TITLE	<b>PROJECT VICINITY</b>	
AGENCY	FEMA	FIGURE <b>1</b>
PROJECT	Ludlowville Streambank Stabilization Project

Re: FEMA Streambank Stabilization  
Vic. 244 Ludlowville Rd.  
T/Lansing, Tompkins County  
12PR04958

SUBJECT: Response to Request for Project Review Department of Army Application No. 2012-00906, New York State Department of Environmental Conservation No. 7-5032-00241

**From:** [Richert, Suzanne](#)  
**To:** [Doran, Sandra](#)  
**Cc:** [Odutola, Yemi](#); [Gian Dodici](#); [tphillips@bartonandloguidice.com](mailto:tphillips@bartonandloguidice.com)  
**Subject:** reponses to questions RE: FEMA Ludlowville Streambank Stabilization  
**Date:** Thursday, December 13, 2012 9:17:00 AM  
**Attachments:** [560013 Drawing Sheet 1 \(Plan\) FINAL.pdf.pdf](#)  
[560013 STRCUTURE DESIGN SHEET 2 FINAL.pdf.pdf](#)

TITLE	Streambank Stabilization Project Details		
AGENCY	FEMA		
PROJECT	LPDM-PI-02-NY-2008-025		
SOURCE	Barton & Loguidice, P.C., May 2011		
		FIGURE	3

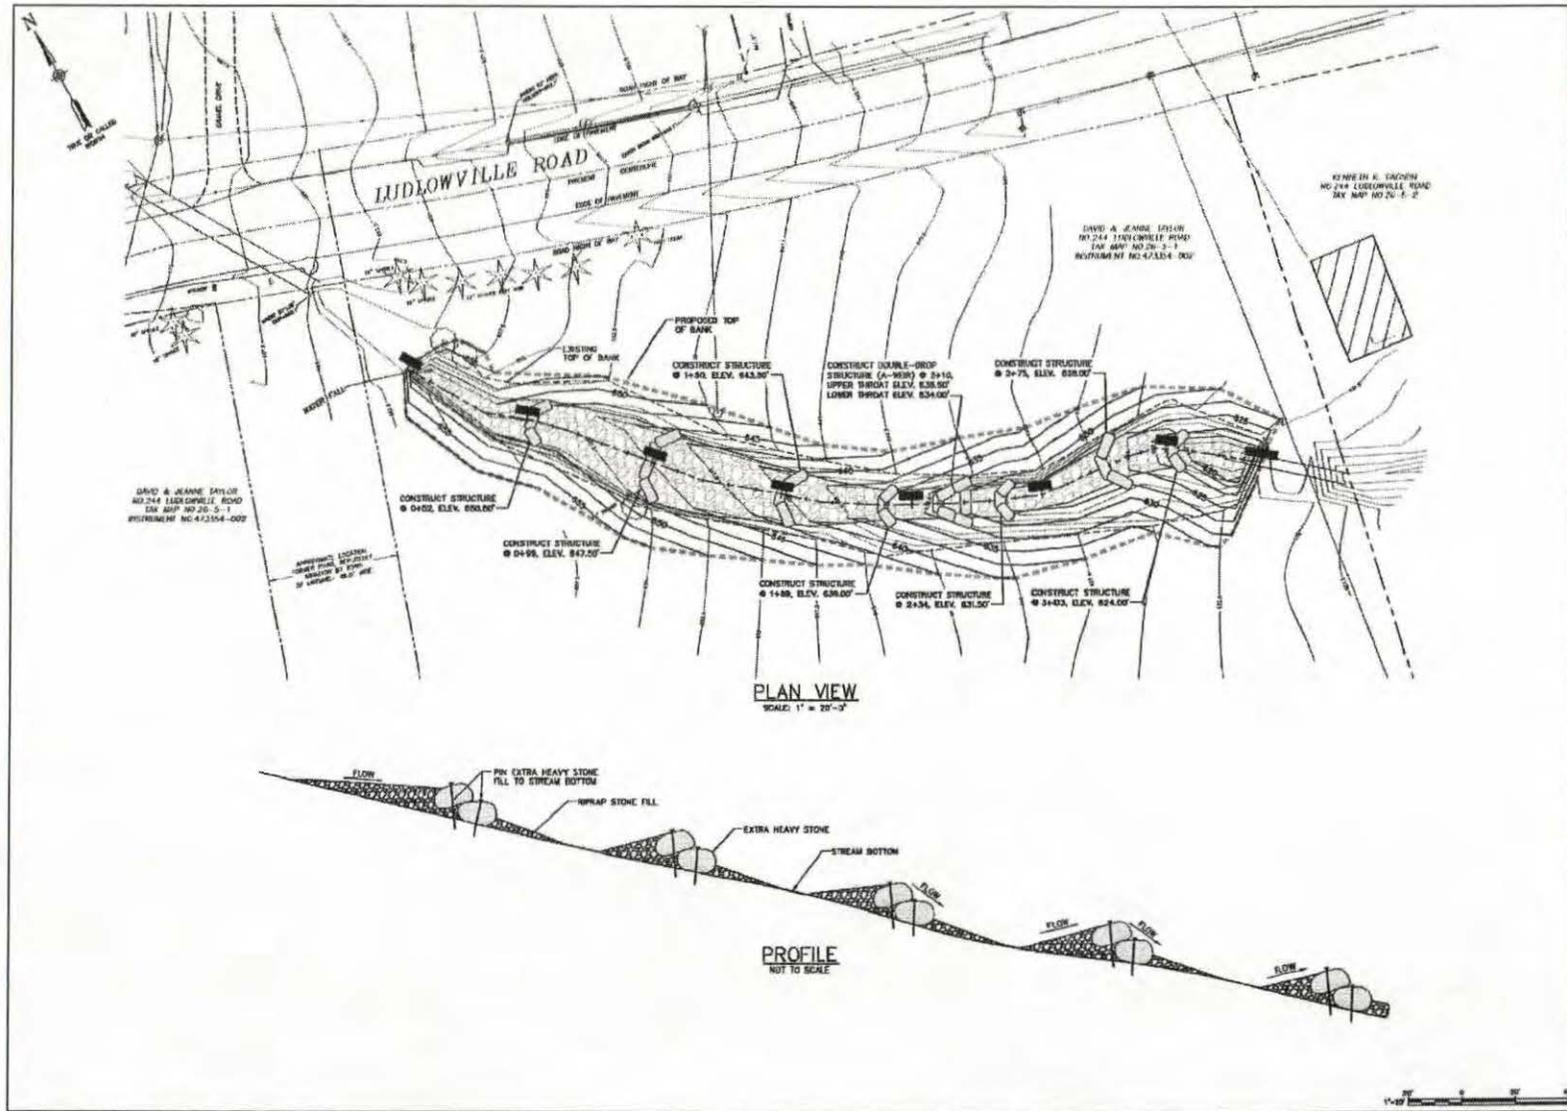
***Question: The cross-sectional diagram did not provide pool to pool spacing***

***Question: The cross-sectional diagram did not provide max pool depth – max pool depth appears to be 0.5 ft?***

***Question: How are they going to tie back the rock into the bank (distance)?***

***Question: Will the rock be placed at the toe of slope for the entire reach?***

I reviewed the cross sectional diagram. It did not provide pool to pool spacing and max pool depth. Max pool depth appears to be .5 ft?? Also, how are they going to tie back the rock into the bank (distance) and will the rock be placed at the toe of slope for the entire reach?

Answer: The spacing between pools can be determined by looking at Sheet 1. The proposed cross-vane locations have a station number assigned to them, which would directly correspond to the distance between pools as well. Because the primary reason for the project is to provide a mechanism for bank stabilization, and not natural channel restoration, the placement, spacing, and number of the structures is driven strictly by the results of hydraulic modeling of pre- and post-construction channel conditions. The intent is to provide maximum reduction of shear stress on the streambed and, in particular, at the toe of slope in a manner that maintains permanent grade control by establishing pool depths upon the existing exposed bedrock.

Answer: Based on the provided elevations for the cross-vanes, the max pool depth varies from one step pool to another. Pool 1 is located immediately downstream of cross vane 1 (CV) at 0+52 on Plan Sheet 1. The proposed elevation of the throat at CV1 is 650.5, the pool bed elevation immediately below this structure will be approximately 645.5 due to proposed rock thickness being around 2.5 feet. This results in approximately 5 feet of drop from top of upstream CV to pool bed elevation based on two tiers of rock per cross vane. Water will naturally back up to an elevation of 647.5, which is the elevation of the second cross vane at 0+99. This results in the max depth of Pool 1 being approximately 2.0 feet. The following is a list of max pool depths beginning at the furthest upstream.

Pool 1 – 2.0 feet  
Pool 2 - 1.0 foot  
Pool 3 – 0.5 foot  
Pool 4 – 2.4 feet  
Pool 5 – 3.4 feet  
Pool 6 – 2.5 feet  
Pool 7 – 1.5 feet  
Pool 8 – 1.0 foot

Answer: The arm rock of the CVs will be tied into the bank approximately 2-3 feet as shown on the typical CV detail on Sheet 2. The proposed rebar will aid in anchoring the CVs, as will the rip rap bank stabilization. Given the slope, lack of sinuosity, and step-pool (type-A channel) character of the

design bed, keyway lengths typically do not need to be as long as they would in a system more prone to lateral migration. As for a tie-back distance, this is still up in the air because of the uncertainty of how much bank excavation can be done to build keyways without having the entire bank fail due to the steepness and soil composition of the banks. Keyway length will be determined onsite by the design contractor construction oversight specialist based upon the factors listed above.

**Answer:** The entire 330 feet of stabilization calls for rip rap at toe of bank and along portions of the bed, as well as bank shaping to allow for a wider floodplain. The floodplains would receive the bank treatment identified on Sheet 2.
